7.2 Reactor Protection (Trip) System (RPS)—Instrumentation and Controls

The information in this section of the reference ABWR DCD, including all subsections, tables and figures, is incorporated by reference with the following departures and supplements.

STD DEP T1 2.3-1 (Table 7.2-1, 7.2-2, Figures 7.2-2, 7.2-6, 7.2-9, 7.2-10)

STD DEP T1 3.4-1 (Figures 7.2-2, 7.2-9, 7.2-10)

Figure 7.2-2 Reactor Protection System Equipment Arrangement (From Sensors Through Trip Actuators)

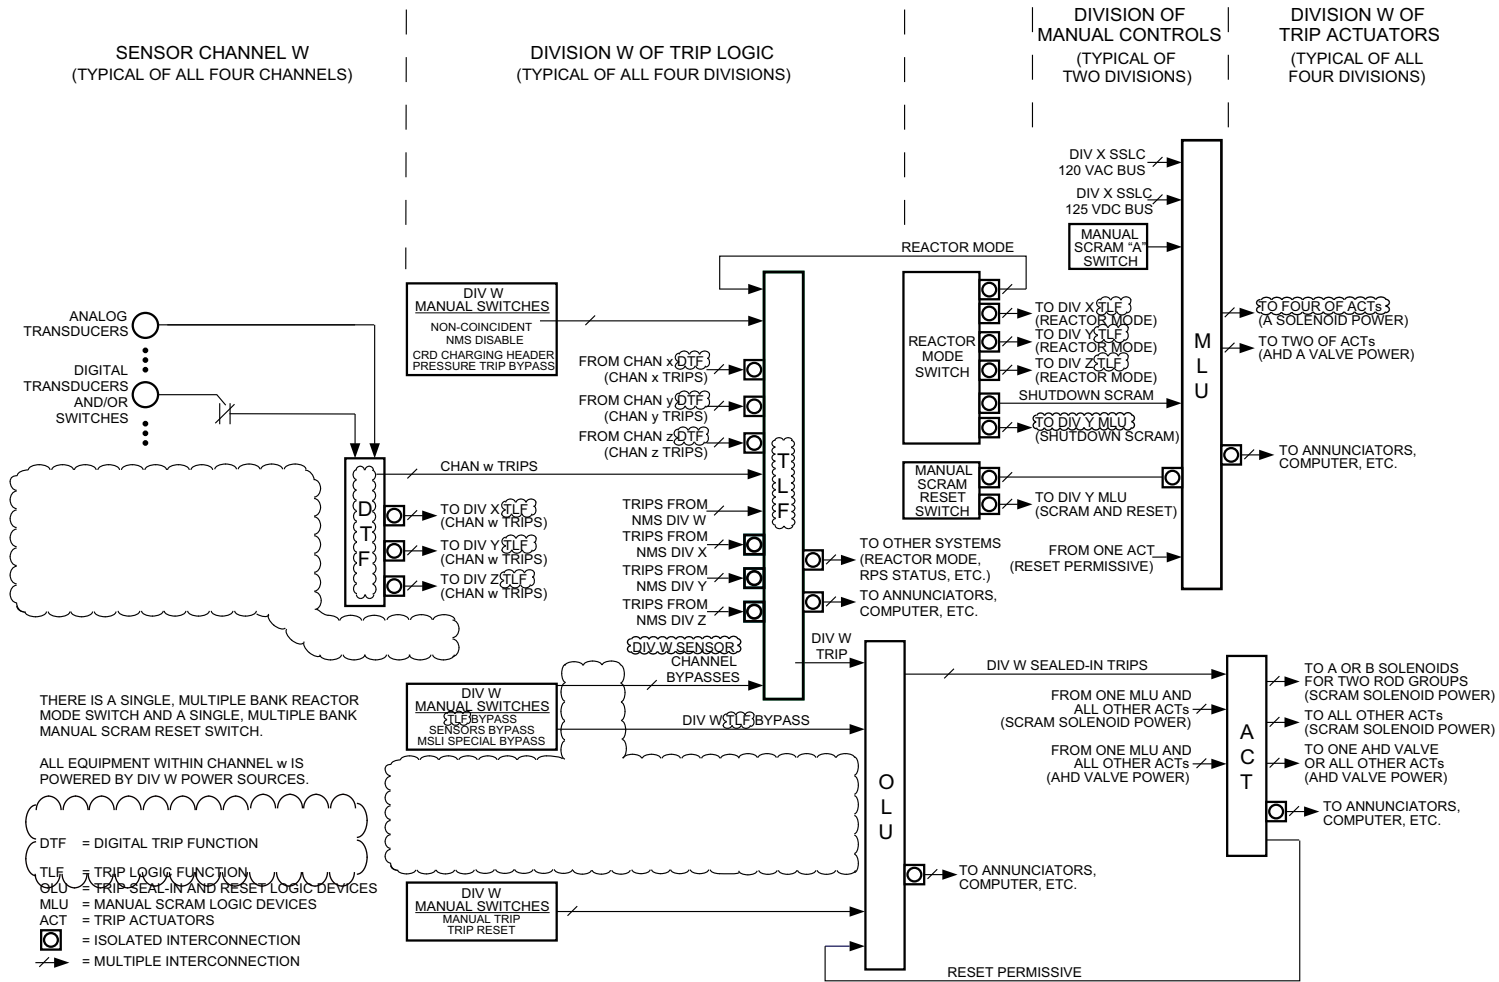
The RPS equipment is divided into four redundant divisions of sensor (instrument) channels, trip logics and trip actuators, and two divisions of manual scram controls and scram logic circuitry. The sensor channels, divisions of trip logics, divisions of trip actuators and associated portions of the divisions of scram logic circuitry together constitute the RPS scram and air header dump (backup scram) automatic initiation logic. The divisions of manual scram controls and associated portions of the divisions of scram logic circuitry together constitute the RPS scram and air header dump manual initiation logic. The automatic and manual scram initiation logics are independent of each other. RPS equipment arrangement is shown in Figure 7.2-2.

Equipment within a sensor channel includes primarily sensors (transducers or switches), ~~multiplexers and digital trip modules (DTMs)~~ trip functions (DTFs). The sensors within each channel monitor plant variables (Subsection 7.2.1.1.4.2) ~~and send either analog or discrete output to remote multiplexer units (RMUs) within the associated division of Essential Multiplexing System (EMS) the DTF.~~ Each division of the EMS performs analog to digital conversion on analog signals and sends the digital or digitized analog output values of all monitored variables to the DTM within the associated RPS sensor channel. The ~~DTM DTF~~ in each sensor channel compares individual monitored variable values with trip setpoint values and for each variable sends a separate, discrete (trip/no trip) output signal to all four divisions of trip logics.

Equipment within a division of trip logic includes primarily manual switches, ~~bypass units (BPUs)~~ bypass interlock functions, ~~trip logic units~~ functions (TLUs/TLFs) and output logic units (OLUs). The various manual switches provide the operator means to modify the RPS trip logic for special operation, maintenance, testing and reset. The ~~BPUs~~ bypass interlock functions enforce restrictions on bypassing multiple divisions of related functions. The bypass interlock functions perform bypass and interlock logic for the channel sensors bypass, main steamline isolation trip special bypass and division trip logic unit bypass. These three bypasses are all manually initiated through ~~individual~~

~~keylock~~~~bypass~~ switches within each of the four divisions. Each ~~BPU~~~~bypass~~ switch sends a separate bypass signal for all four channels to the ~~TLUTLE~~ in the same division for channel sensors bypass and MSL isolation trip special bypass. Each ~~BPU~~~~bypass~~ switch sends the ~~TLUTLE~~ bypass signal to the OLU in the same division.

Figure 7.2-6 Division 1 Trip Logic

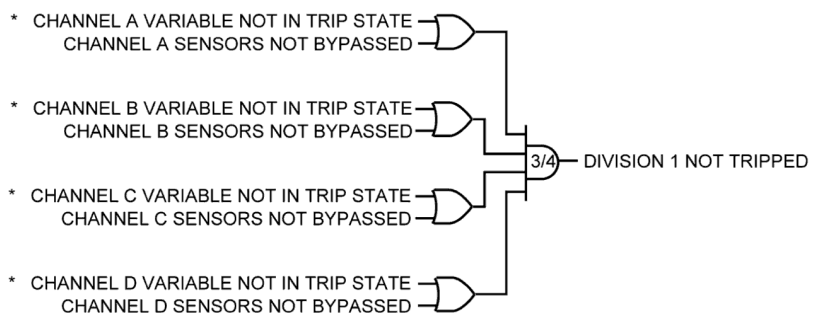
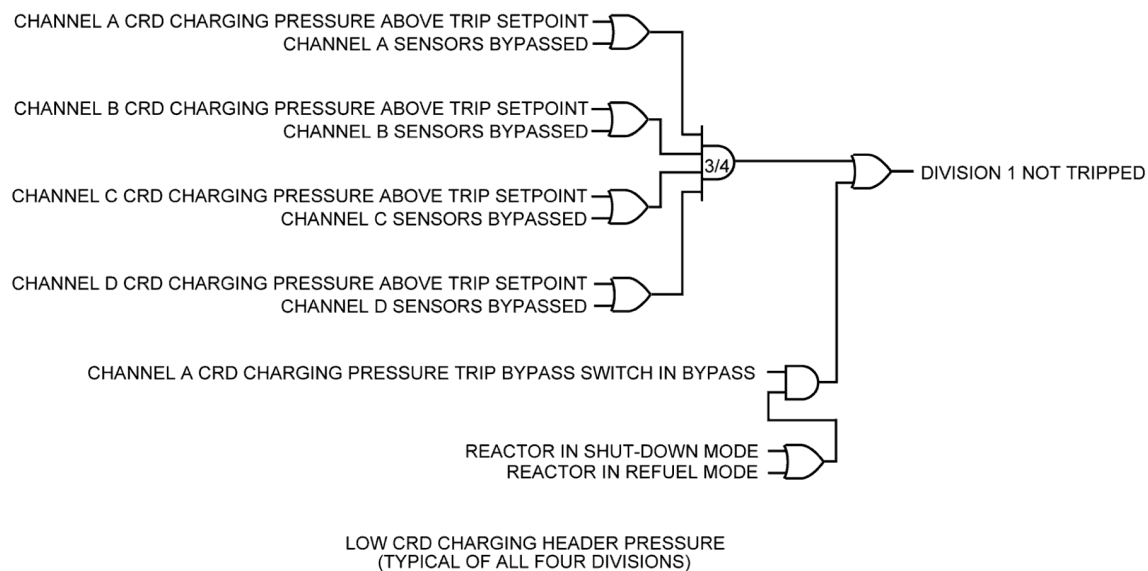
Suppression pool temperature is measured at ~~four~~ physically separated locations by locally mounted sensors. ~~Each sensor is on a separate instrument line and provides analog equivalent of suppression pool temperature to the EMS which,~~ These sensors are monitored by divisional I/O devices which digitize the signals and, in turn, provide ~~provides~~ digitized suppression pool temperature data to the suppression pool temperature monitoring (SPTM) module of SSLG the reactor trip and isolation system (RTIS). ~~SSLG~~ The SPTM module, after processing and averaging the data, provides the trip signal to the corresponding RPS divisional ~~DTM~~ DTE, when the calculated average temperature exceeds the setpoint.

(4) ~~Process Radiation Monitoring (PRM) System (Figure 7.2-6)~~ Not Used

~~High Main Steamline Radiation Trip (Figure 7.2-6)~~

~~A high main steamline radiation trip will occur in each division of trip logic when a main steamline radiation trip condition exists in any two or more unbypassed sensor channels. There are no operating bypasses associated with this trip function.~~
